**SUBDIVISION REVIEW SHEET****CASE NO.:** C8-2019-0185.0A**COMMISSION DATE:** June 23, 2020**SUBDIVISION NAME:** Armadillo Parks resubdivision**ADDRESS:** 901 and 906 Armadillo Road**APPLICANT:** David Cox (Verde Ville, LLC)**AGENT:** George Gonzalez (Genesis 1 Engineering Co.)**ZONING:** SF-3-NP (single family residence)**NEIGHBORHOOD PLAN:** Garrison Creek**AREA:** 0.703 acre (30,642 sf)**LOTS:** 5**COUNTY:** Travis**DISTRICT:** 2**WATERSHED:** Gilliland Creek**JURISDICTION:** Full Purpose**SIDEWALKS:** Sidewalks will be constructed along Armadillo Road, Cooper Lane and Antelope Circle.**VARIANCES:** none

CITY OF AUSTIN –DEVELOPMENT SERVICES DEPARTMENT  
SUBDIVISION APPLICATION – MASTER COMMENT REPORT

CASE NUMBER: C8-2019-0185.0A  
UPDATE: U1  
CASE MANAGER: Steve Hopkins      PHONE #: 512-974-3175

PROJECT NAME: Armadillo Parks - Resubdivision  
LOCATION: 901 ARMADILLO RD

Exhibit B: Proposed plat

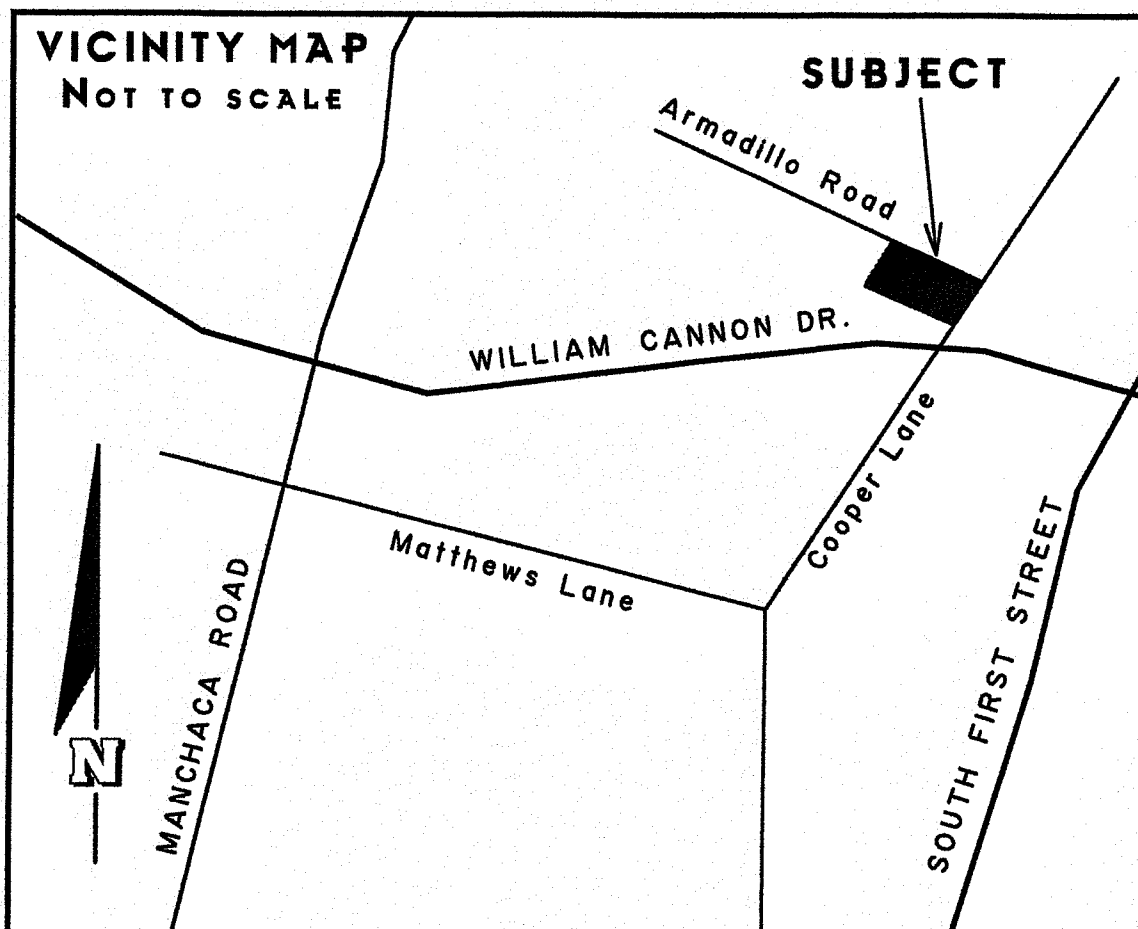
DE1: Per LDC 25-5-1, Please add the following note: "No structure shall be occupied until the water quality control and detention facility have been constructed, inspected, and accepted by the City of Austin."

U1: Comment not addressed. Note not found.

DE2: Fiscal arrangements are required for street, sidewalk, drainage, restoration, erosion controls and boundary street improvements [LDC 25-1-112]: In the City of Austin jurisdiction, fiscal surety is not collected for local streets and drainage. Please contact me to discuss what will need to be included in the fiscal estimate. Remember to include fiscal for sidewalks located next to greenbelts, open spaces, landscape areas, and other common areas. Please provide an engineer's estimate of fiscal requirements for review and approval.

U1: Comment stands.

PR 2: To show compliance with City Code §25-1-601, add the following note to the plat: "A fee-in-lieu of parkland dedication and park development has been paid for 10 dwelling units."

WQ2: ECM 1.6.7(H)(2) Soil conditions - When siting a full or partial infiltration rain garden, appropriate soil conditions must be present. The depth to an impermeable layer must be at least 12 inches below the bottom of the rain garden. For full infiltration rain gardens, the underlying native soil must have a design infiltration rate that will draw down the full ponded depth in less than 48 hours. For example, for a 12-inch maximum ponding depth, the design infiltration rate must be at least 0.25 inches per hour. For a 6-inch maximum ponding depth, the design infiltration rate must be at least 0.13 inches per hour. For a 3-inch maximum ponding depth, the minimum design infiltration rate is 0.06 inches per hour. The design infiltration rate is based on applying at least a factor of safety of two (2) to the measured steady state saturated infiltration rate (i.e., the design infiltration rate is equal to one-half of the measured infiltration rate). A higher factor of safety may be used at the discretion of the design engineer to take into variability associated with assessment methods, soil texture, soil uniformity, influent sediment loads, and compaction during construction. For full infiltration systems, the infiltration rate of the soil subgrade below the growing medium of the rain garden must be determined using in-situ testing as described in Section 1.6.7.4. If a range of values is measured then the geometric mean should be used.

U1: Comment stands

WQ3: ECM 1.6.8 states, "On-site control of the two-year storm is achieved when the developed-conditions peak runoff rate leaving the site for a given drainage area is less than or equal to the existing-conditions runoff rate. The flow rates can be considered equal if the developed rate is no more than one-half (0.5) cfs greater than the existing rate or if the developed rate is no more than one-half (0.5) percent greater than the existing rate and there are no existing erosion problems downstream of the site" (LDC 25-7-61). Please provide compliance.

U1: Please provide an electronic copy of the model used to address this comment.

WQ4: For stacked detention, the velocity of the flows entering the SCM for the developed 100 year peak flow must not exceed two feet per second. ECM 1.6.2 B.2.

U1: Comment not addressed.

WQ6: ECM 1.6.7(H)(2) Land Use - The use of rain gardens as a water quality control is limited to Commercial, Multi-Family, Civic Uses, Public Right of Way , and single family residential projects. The restrictions on use of rain gardens for single family residential are as follows:

1. Rain Garden must be located in a dedicated common area or within a drainage easement that is accessible by standard maintenance equipment from the right of way.
2. A minimum of four (4) single-family lots must be treated by the rain garden.
3. No rain gardens are to be located in backyards or fenced in yards.
4. The City of Austin will provide functional maintenance per City Code Section 25-8-231. Homeowners may add additional native landscaping and provide care that is more frequent.

U1: Comment not addressed.

**U1: Cleared.**
